Dublin Cycling Campaign

30 August 2022

Blanchardstown to City Centre Core Bus Corridor (Case: 313892)

Figure 1 Blakestown Rd Junction showing no car slip lane in final public consultation round.

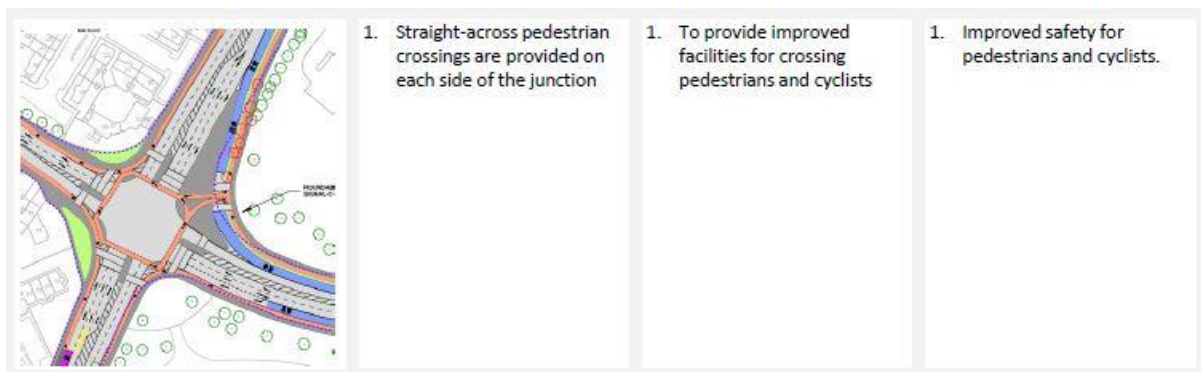
For example, "*TIA Sub Appendix 2 - Junction Design Report*" shows the design evolution of the Blanchardstown Road South / Blakestown Way junction (general arrangement drawing sheet 4). The July 2021 iteration re-adds a left-turn slip for general traffic in order to improve junction capacity for motor traffic (as shown in Figure 1 below).

Proposed vehicle slip lanes, where vehicles can cut across people cycling, sometimes at relatively high speeds, are proposed once again, particularly in the Blanchardstown area. None of the junctions around Blanchardstown reflect any of the four junction types developed in the '*Preliminary Design Guidance Booklet for BusConnects Core Bus Corridors (PDGB) (NTA 2021)*' in Appendix A4.1. This issue of inappropriate slip lanes has been raised through the various iterations of this scheme, and yet remains to be comprehensively addressed.

Note the conflicting rationale stating the addition of a vehicular slip lane brings the junction into line with BusConnects PDGB principles. As stated previously, none of the junction types outlined in PDGB recommend slip lanes.

DMURS 4.4.3 states that designers “*should omit left-turn slips as they encourage high traffic speeds and are highly disruptive for people walking and cycling*”. As per the present [National Cycle Manual](#) Section 7.8, the vehicle slip lanes should be removed, particularly at this location in the context of a major town centre.
